Amendments to the Drawings:

REMARKS

The above-identified application has been amended in response to the Office Action mailed August 23, 2007.

FIG 1

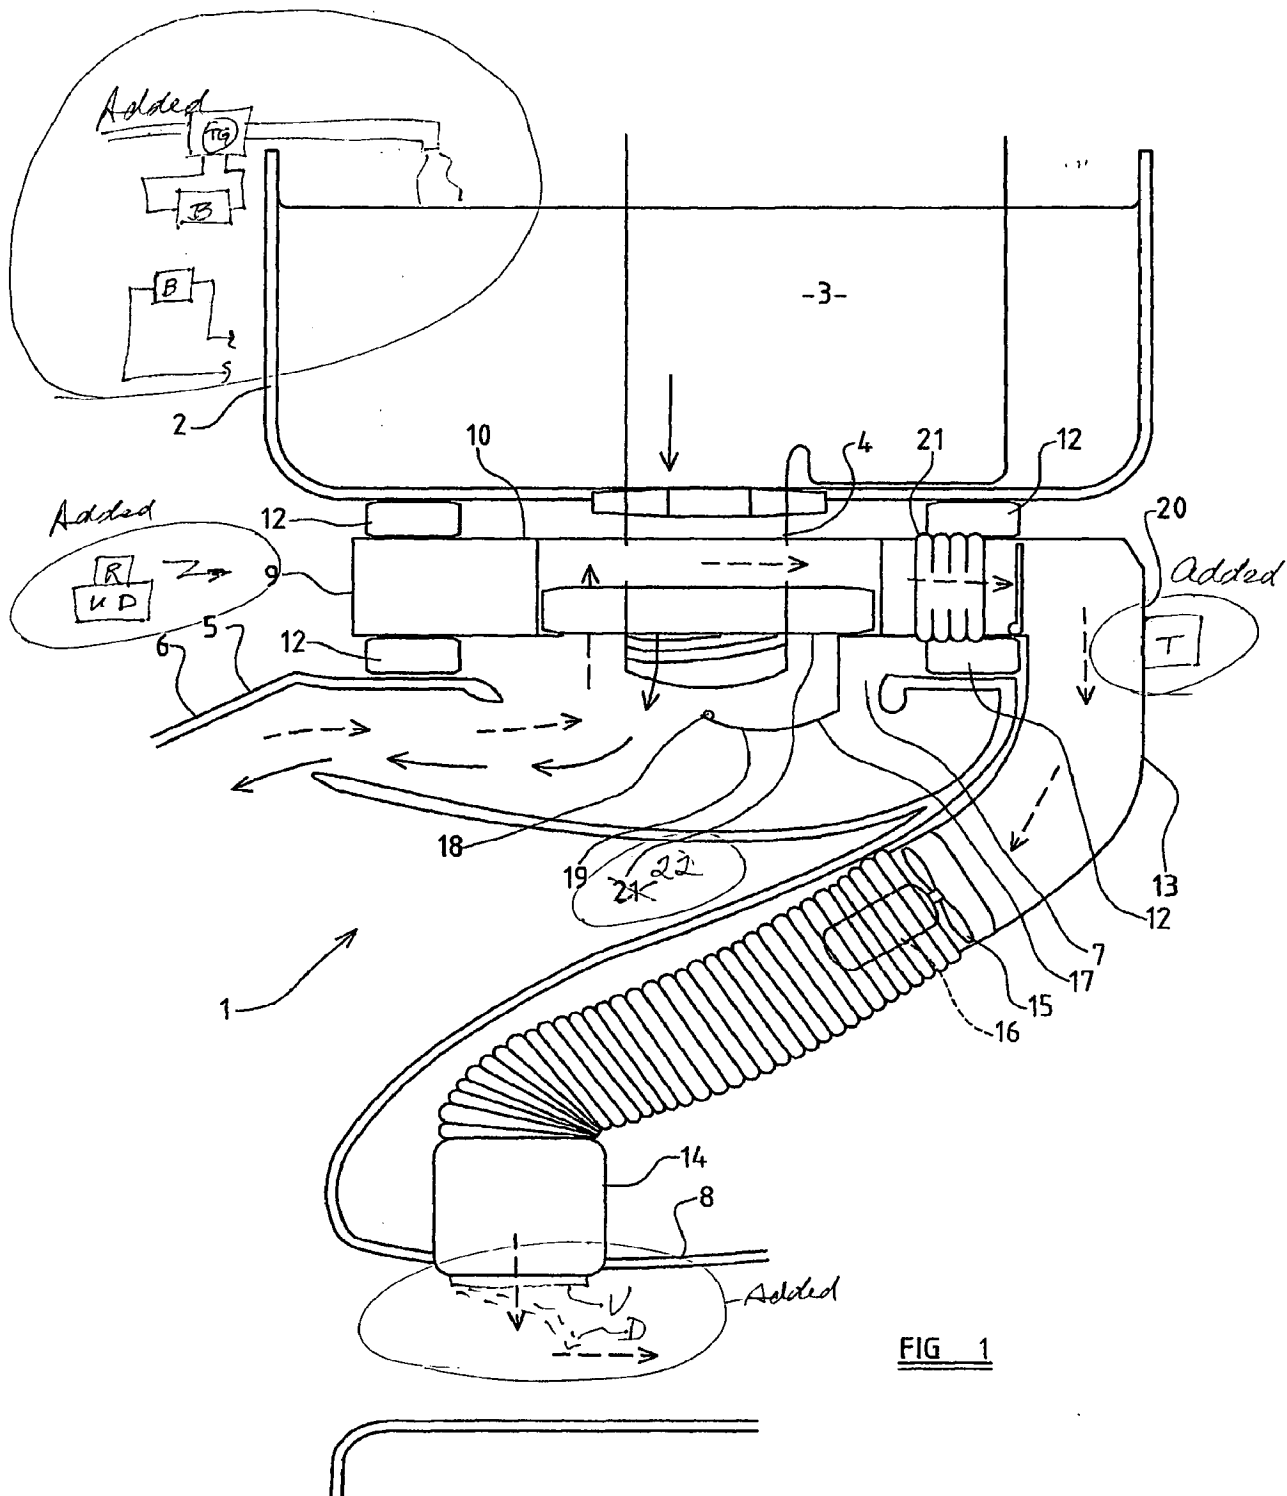
The attached sheet of drawings includes changes to FIG. 1 and replaces the original sheet including FIG. 1. A use detection mechanism UD, a wireless connection R, a timer T, a valve V, a diaphragm D, batteries B, and a power generation element TG have been added to FIG. 1. A duplicate use of reference numeral 21 has been corrected by changing the lower reference numeral "21" to --22--, in connection with the float shown in the middle of the figure.

The Examiner objected to the drawings under 37 CFR §1.83(a) and objected to claims 6-9, 11-12, 14-16, 25-28, 30-31, 33-35, and 38 as lacking support in the drawings for claimed subject matter. Accordingly, FIG. 1 has been corrected to include representation of the subject matter of each of those claims, and the specification has been amended by insertion of reference letters to guide the reader to the various items that have been added to FIG. 1.

A new paragraph [0077.1] has been added to the retyped copy of the specification that was filed as part of the original Section 371 filing, to provide the paragraph that appeared on page 16, at lines 17-24, of the International Publication No. WO 2004/042156 A1, in which the present application was published by WIPO. The inserted paragraph [0077.1] was inadvertently omitted from the specification when it was retyped to permit insertion of paragraph numbers in connection with filing of the United States National Stage application. In paragraph [0077.1] the reference numerals "21" have been amended to read --22--, to agree with correction of duplicate use of reference numeral "21" in FIG. 1.
